S U B M I S S I O N: M U L C A H Y
a written submission by way of further objection to DA 2020/1351

Re:
#1 Bilambee Lane, Bilgola Plateau
DA 2020 1351

WRITTEN SUBMISSION: LETTER OF OBJECTION
Submission: Mulcahy

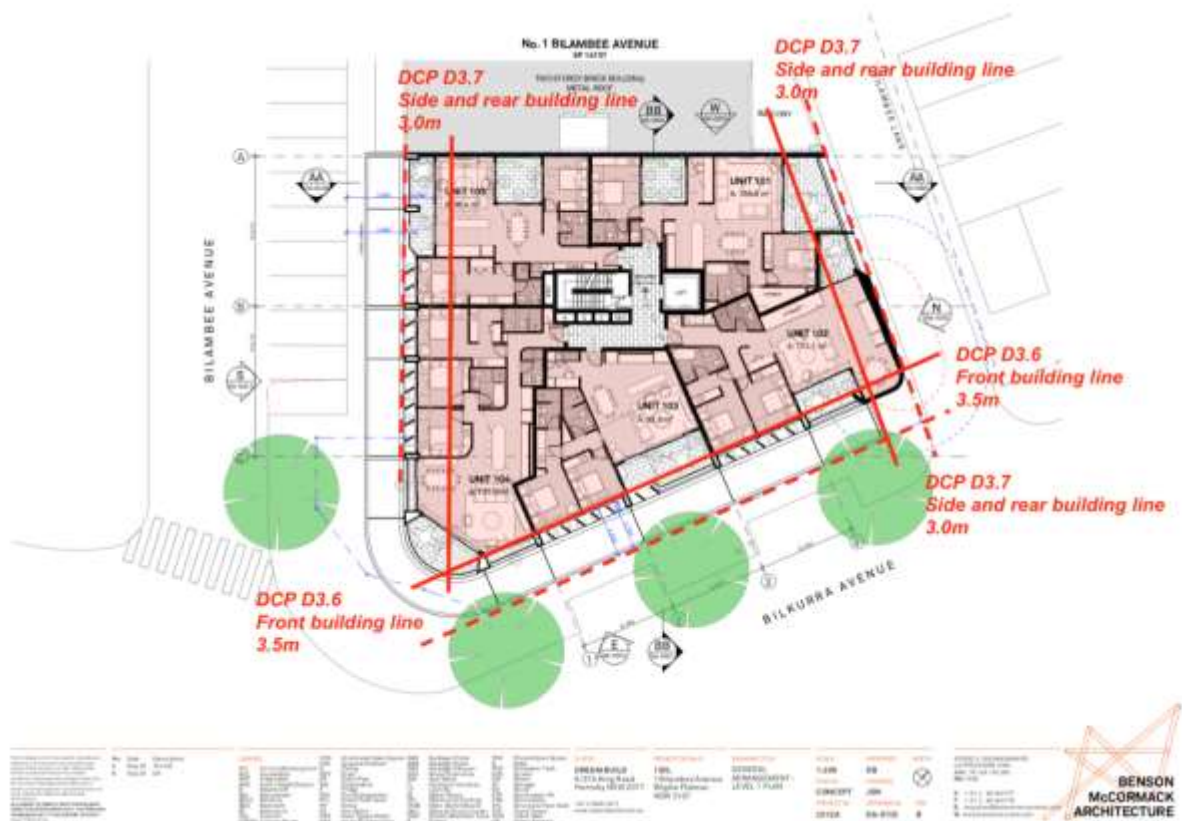
The detailed Submission in November 2021 gave a sketch of the proposed massing from opposite the site. The proposed development presents a three-storey development plus an extensive roof top plant enclosure that will be highly visible to the streetscape. We contend that the entire non-compliant development will be visible from surrounding streets and is unacceptable.
